Executive Director's Recommendation

Commission Meeting: May 2, 2019

PROJECT Perimeter Fence Replacement and Gate Improvements United States National Arboretum 3501 New York Avenue, NE Washington, DC	NCPC FILE NUMBER 8064
SUBMITTED BY United States Department of Agriculture National Arboretum	NCPC MAP FILE NUMBER 43.20(38.40)44910
REVIEW AUTHORITY Federal Projects in the District per 40 U.S.C. § 8722(b)(1) and (d)	APPLICANT'S REQUEST Approval of comments on concept design
	PROPOSED ACTION Approve comments as requested
	ACTION ITEM TYPE Staff Presentation

Proposal: Fence

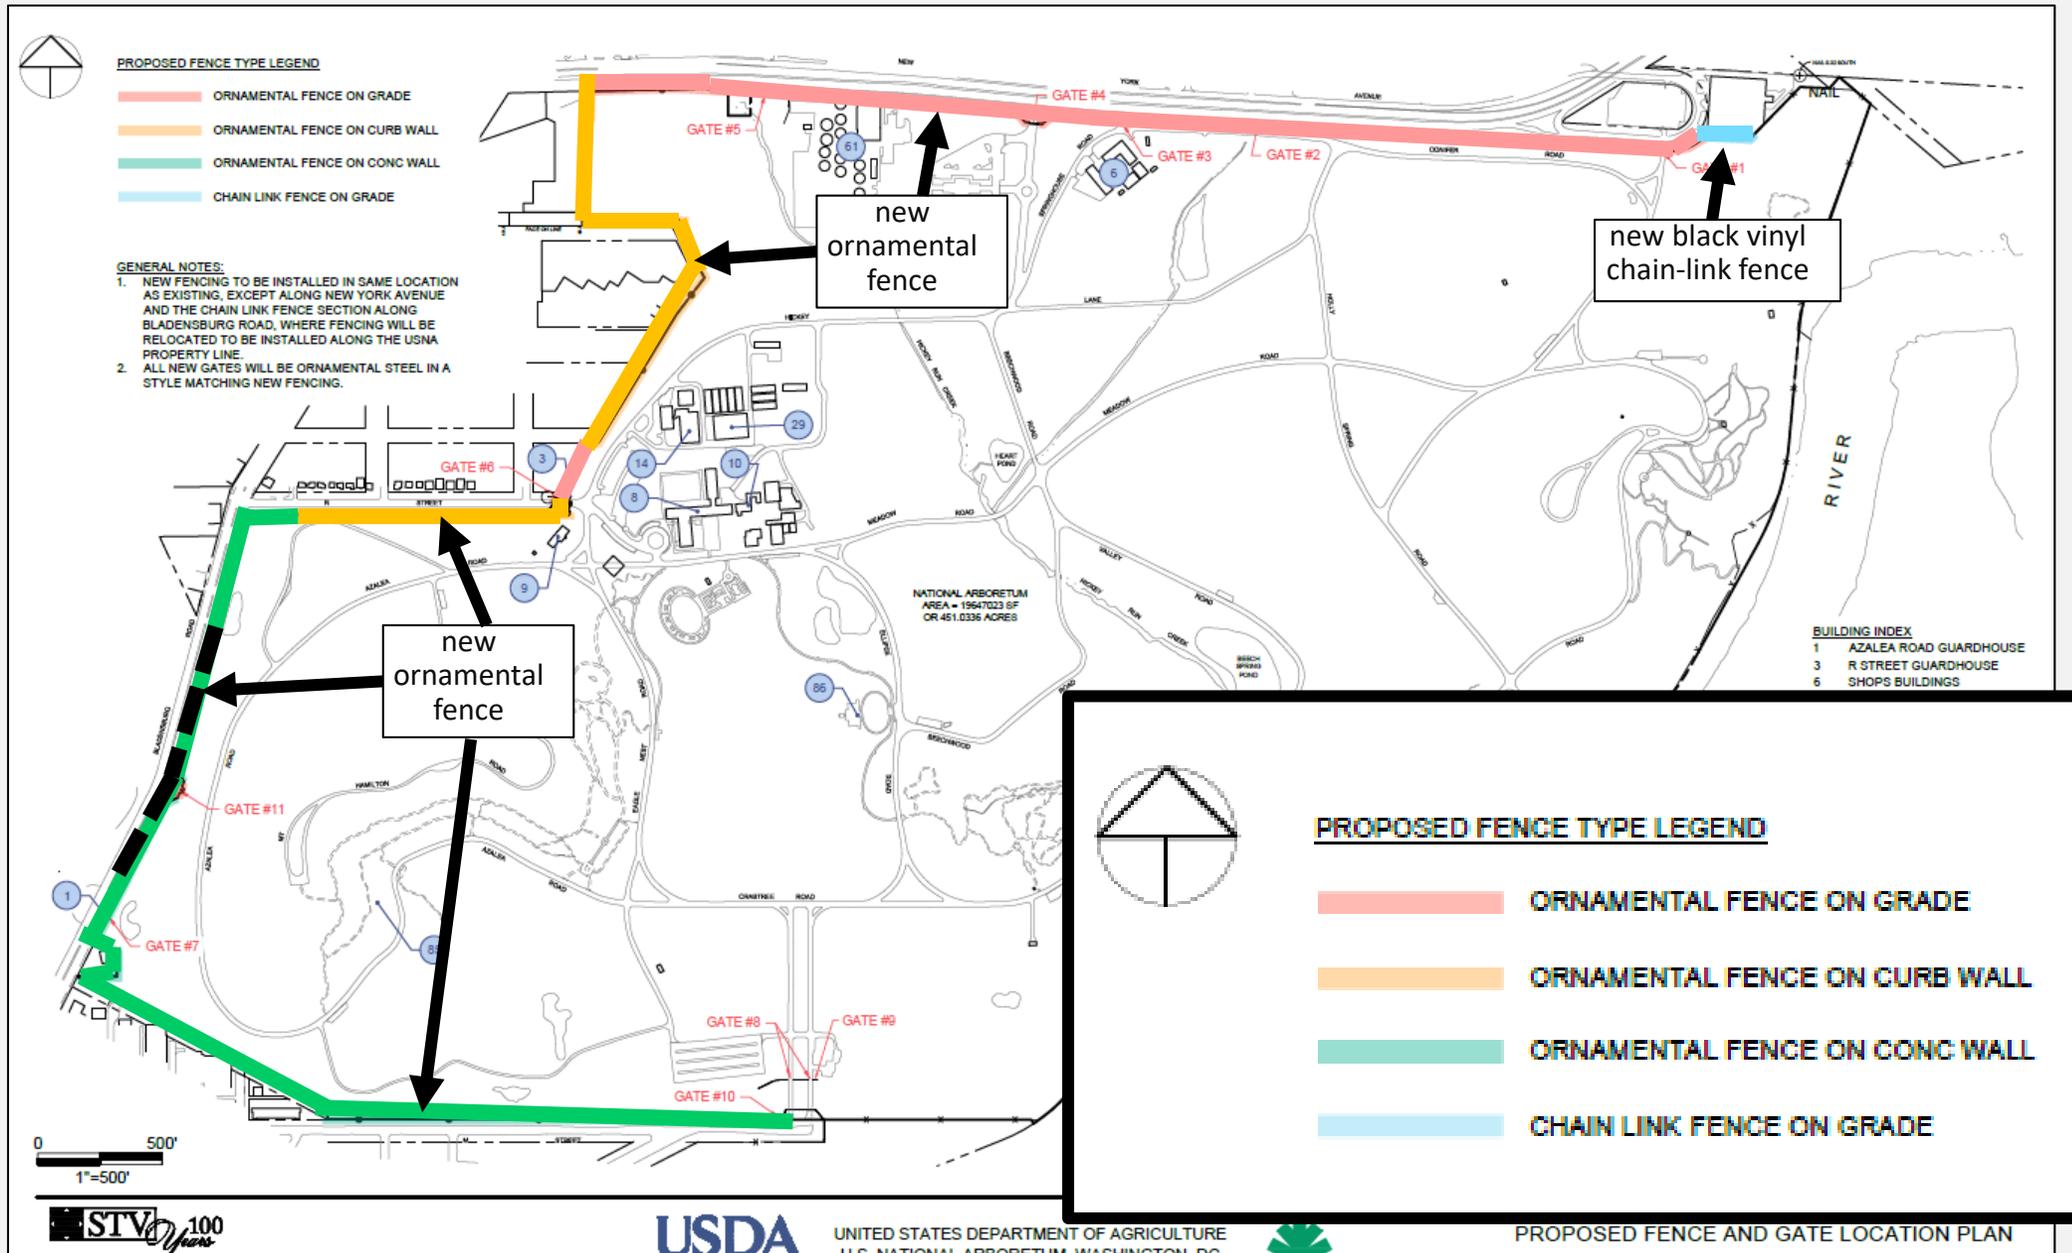
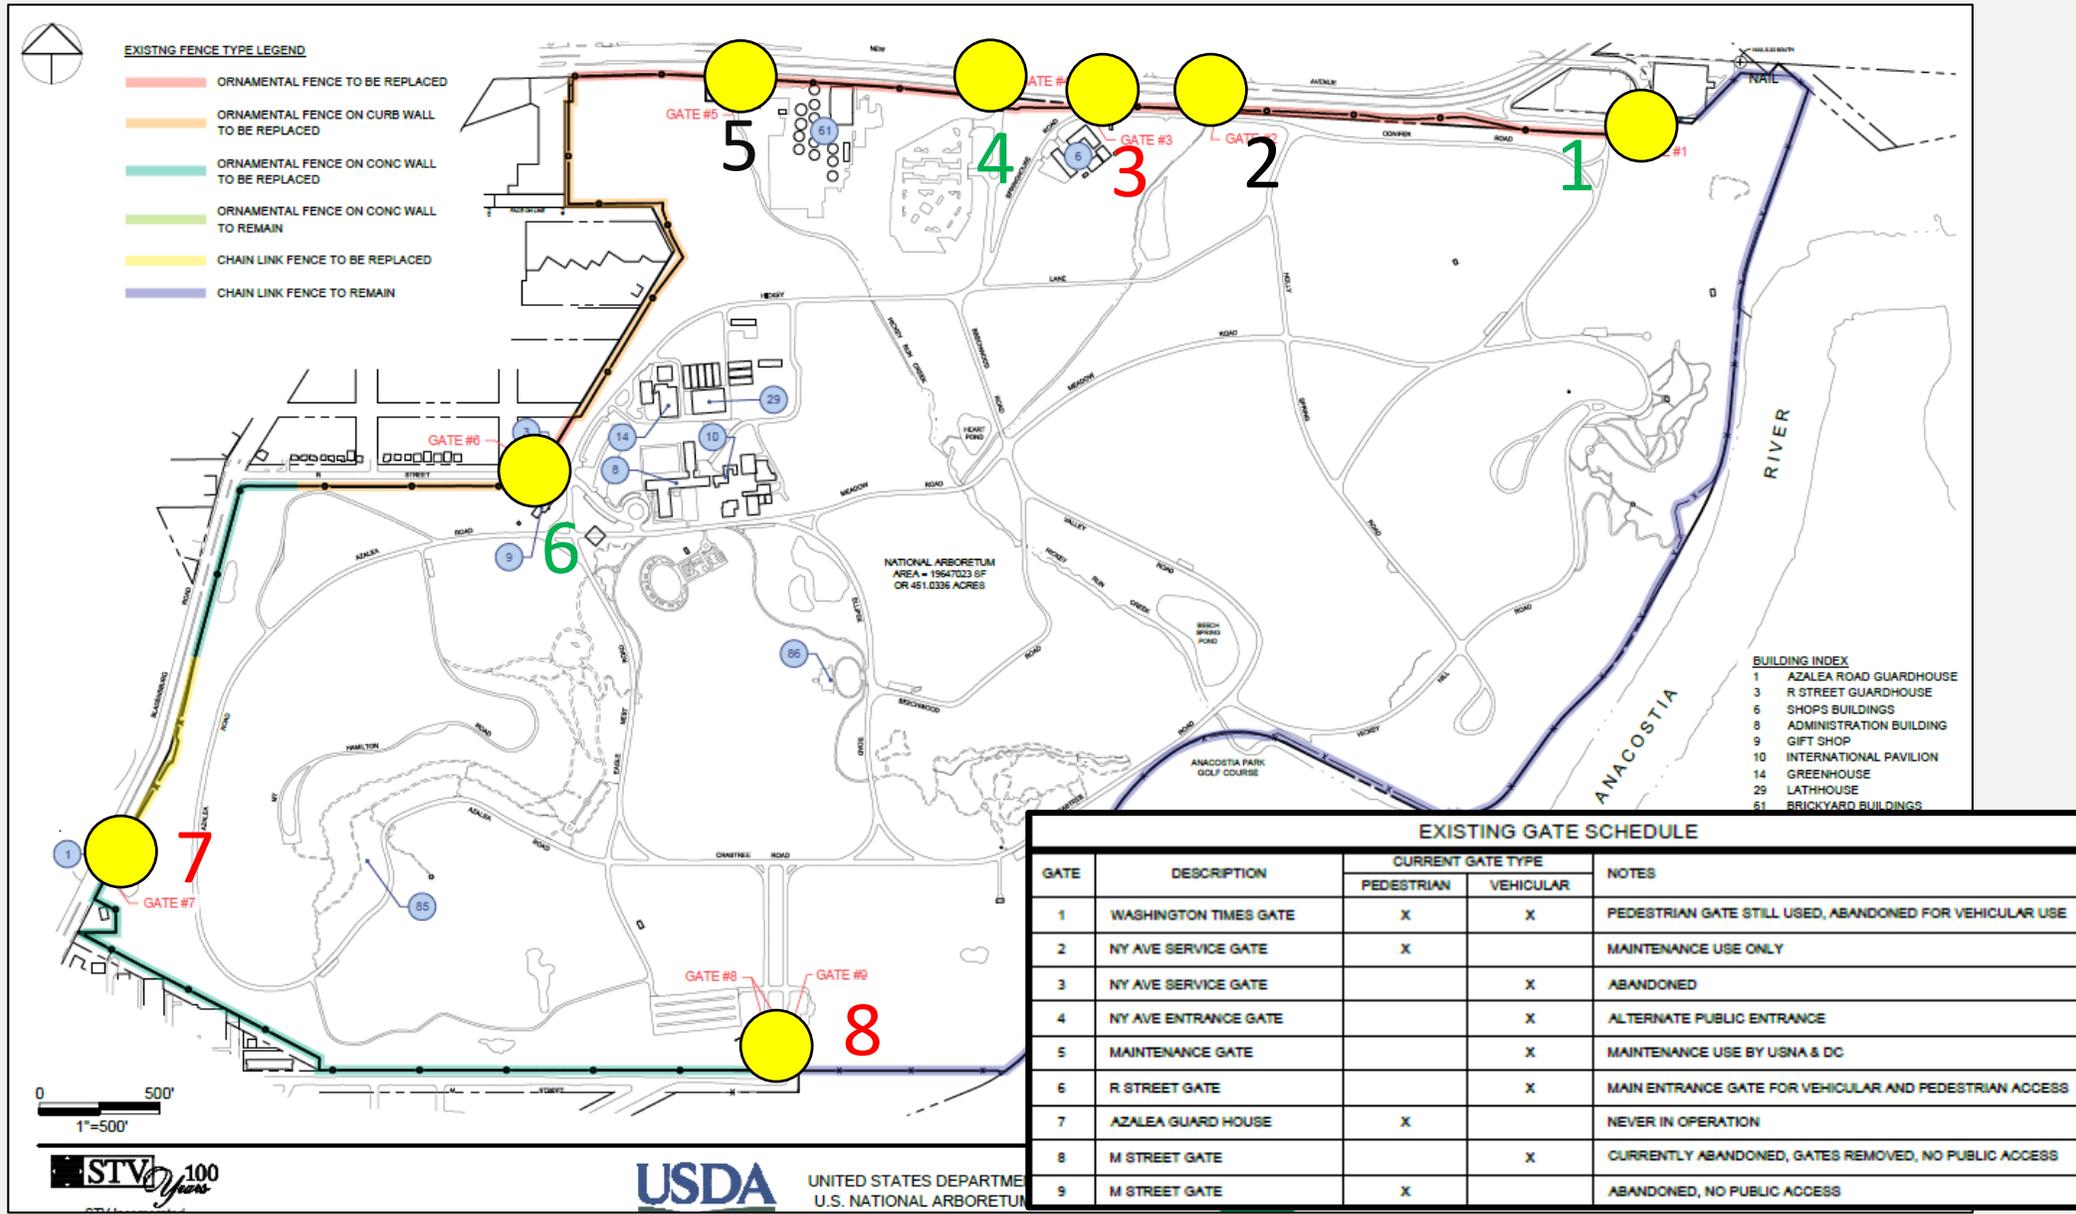
Recommends that the National Arboretum install a single style of new decorative picket fencing that matches the existing style as much as possible, while accommodating the increased height and new picket spacing necessary to support the project goals.

The applicant proposes to replace the existing picket fence with a similar style, though taller (eight feet) and with narrower (four inches on-center) picket spacing. New fence sections will be installed directly into the ground and on top of curb/knee walls as the existing fence. The 855 linear foot chain-link fence section along the western perimeter will be replaced with decorative picket fencing, and an initial 210-foot section of black vinyl chain-link fencing will be installed adjacent to the Washington Times Building in the northeast part of the perimeter. There is currently no perimeter fencing along this area of the Arboretum perimeter. NCPC staff concurs with the concept plan proposal to replace all existing decorative fencing and the section of chain-link fencing along Bladensburg Road with a similar single black picket fence style. The exact fence details will be provided in future submissions for NCPC review once a contractor has been hired to undertake the project. Staff recommends that the Commission **recommend that the National Arboretum install a single style of new decorative picket fencing that matches the existing style as much as possible, while accommodating the increased height and new picket spacing necessary to support the project goals.** Furthermore, staff recommends that the Commission **note that the applicant will submit more detailed fence plans in a future project submission to NCPC for preliminary and final review.**
